Re: Response to Letter Requesting Information from the Millennium Tower Homeowners Association

As requested in your June 5, 2018 letter to Mr. Vision Winter, we are providing you with our opinion about the safety of the existing building foundation for the Millennium Tower at 301 Mission Street on behalf of the Millennium Tower Association.

Figure 7. LERA ETABS Analysis Model

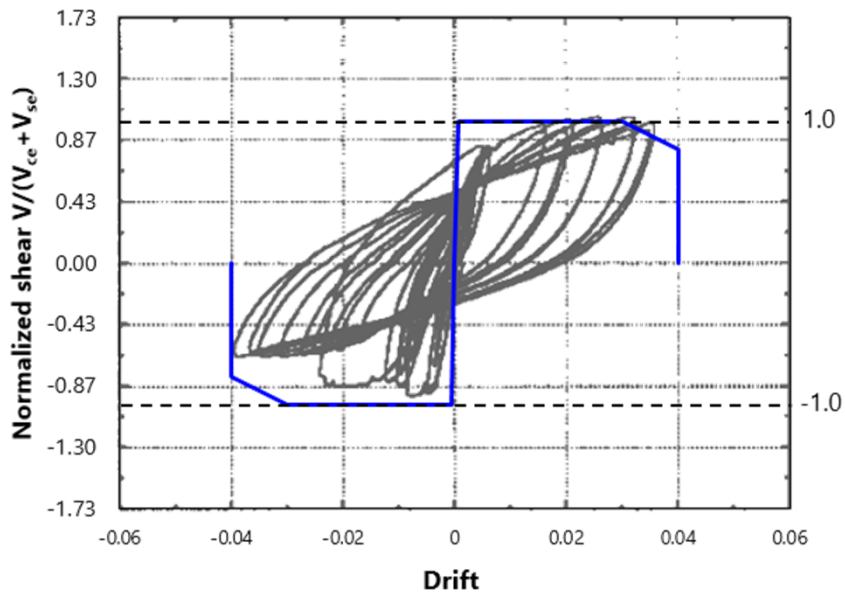
1. Provide a description of the nonlinear analysis models used to evaluate the building, including descriptions of the software used and the types of components employed

In developing our retrofit design, we used a suite of analysis programs, including SAP2000, ETABS, and PERFORM 3D. For the evaluation of the existing building, we used our ETABS model to complete the requested non-linear time history seismic analysis. The ETABS model includes nonlinear representation of the strength, stiffness, and ductility of the various superstructure framing elements using properties based on data provided in ASCE 41 and a selection of commonly referenced research articles for nonlinear analysis. Details on the superstructure modeling are provided in Figures 3-14.

Figure 19. BSE-2N (MCE_R) NLRHA Envelope Results – Story Drifts

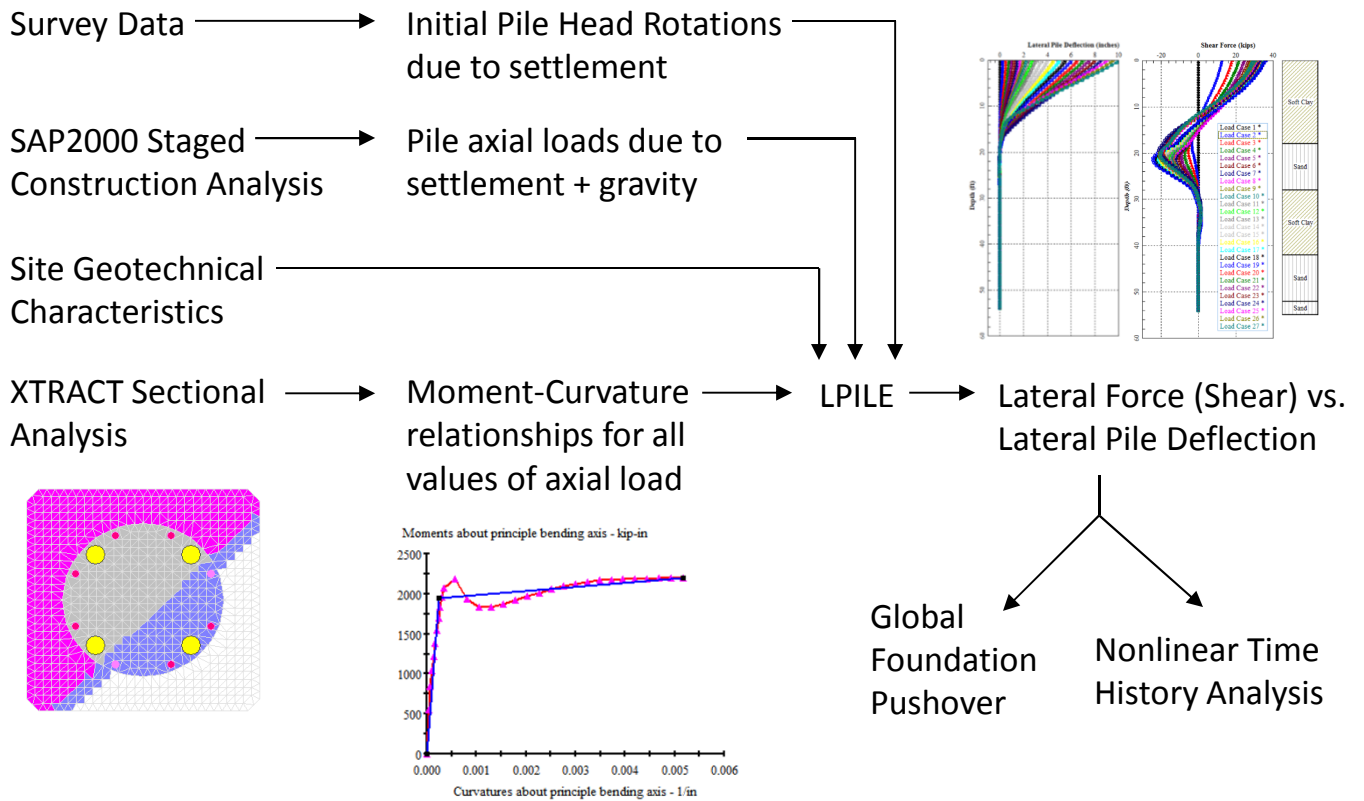
2. Plots of overall lateral building drifts and story drift ratios under MCEr shaking

See Figure 19 for our plots of the average superstructure story drift under MCEr shaking for the ground motions that converged. We found that, for ground motions that converged, the expected building drift meets the current accepted drift limits for new buildings. Further discussion about the MCEr analysis results is included in the following sections.

Figure 21. Individual Pile Lateral Stiffness / Capacity – Axial Load Variation

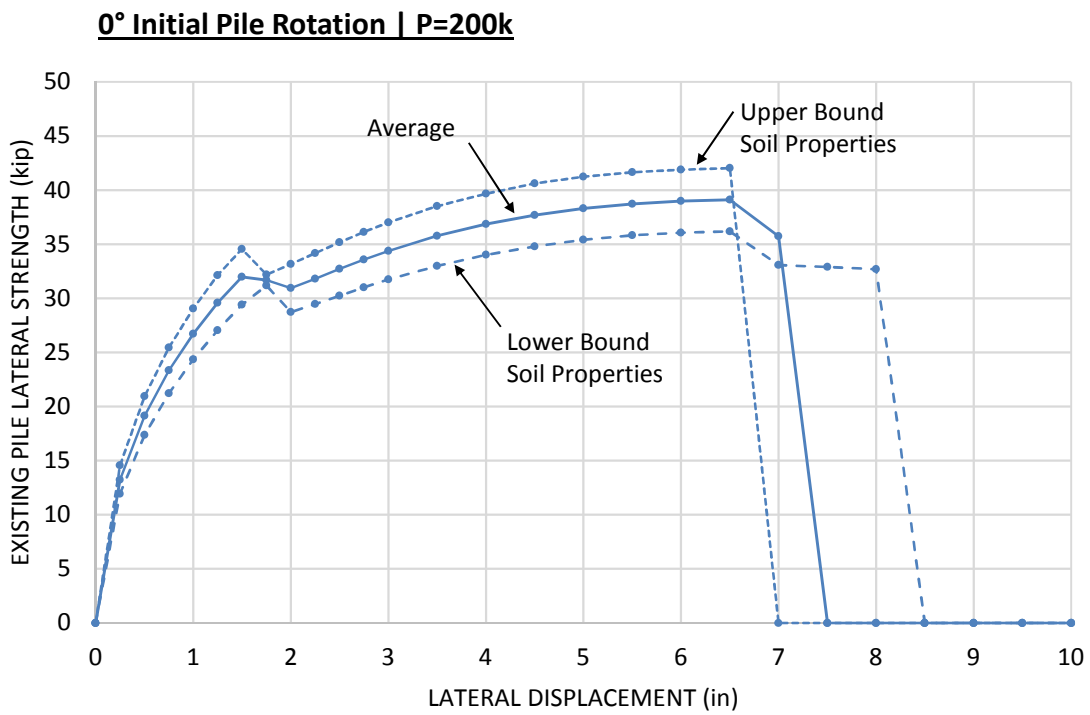
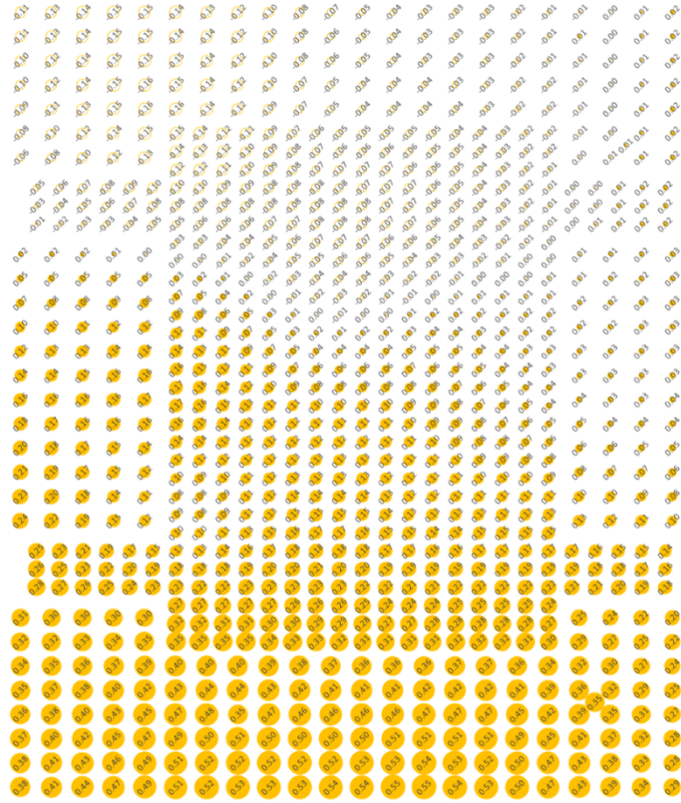
3. Sample lateral capacity curves for existing piles (pile head shear versus displacement)

The existing pile lateral performance is affected by the soil properties, the amount of settlement induced rotation experienced at the top of the pile, the vertical load in the pile, the as-built pile construction record, and the structural non-linear load deformation characteristics of the pile. These variables have all been accounted for in our analysis. The procedure for developing the lateral capacity curves is provided in Figure 20 and sample pile lateral capacity curves for varying axial loads and assumed soil properties are provided in Figures 21 and 22.

Figure 25. BSE-1N (2/3*MCE) NLRHA Results

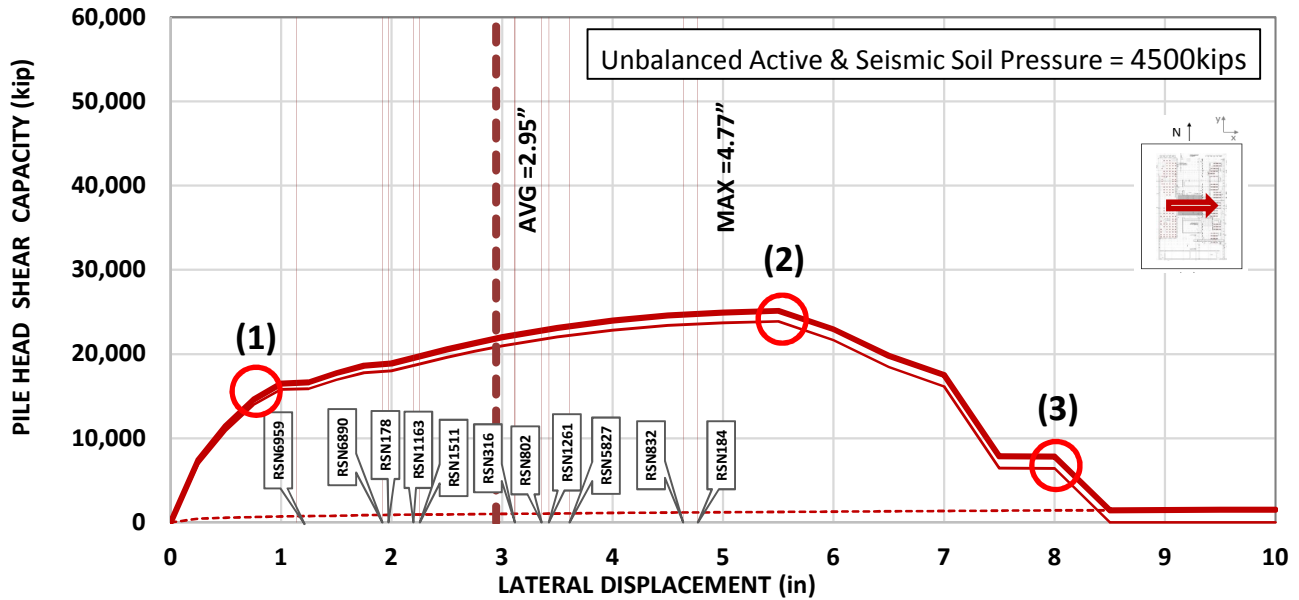
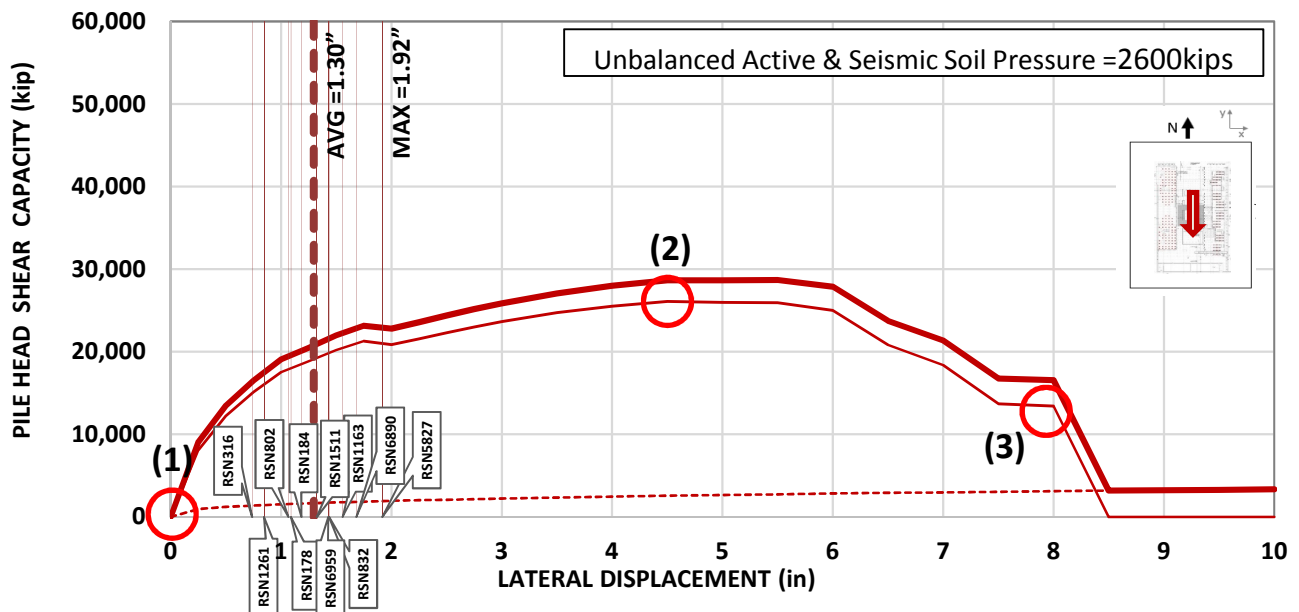
4. **Provide building pushover curves for each principal direction (NS/EW) indicating maximum displacement at top of piles for each record in suite of MCE ground motions and the average of suite and identifying when (1) the first pile yields where it connects to the mat, (2) the first pile hinge experiences significant (>50%) strength degradation, and (3) two hinges form in a critical pile (precursor to a pile side-sway mechanism). Report how many piles experience yielding at the mat connection, significant strength degradation, or double hinging under the average and maximum suite of MCE ground motions.**

Global building pushover curves for each principal direction using lower bound soil properties, pile loading based on our calculated gravity distribution, and accounting for passive pressure have been provided in Figures 25-26 & 29-30. We have indicated your requested points (1) through (3) on each curve as well as the maximum displacement at the top of the piles for each ground motion record. Tables with these displacements and the corresponding maximum base shears for each ground motion have been provided in Figures 24 and 28.

For the average and maximum BSE-1N ($2/3 \times \text{MCEr}$) event ground motions, we found that all the piles will experience yielding but none of the piles are expected to experience significant strength degradation or double hinging. Residual deformations in the foundation due to this yielding have been provided for a representative average ground motion in Figure 27. We find that the residual deformations are within a range that is consistent with Life Safety performance criteria.
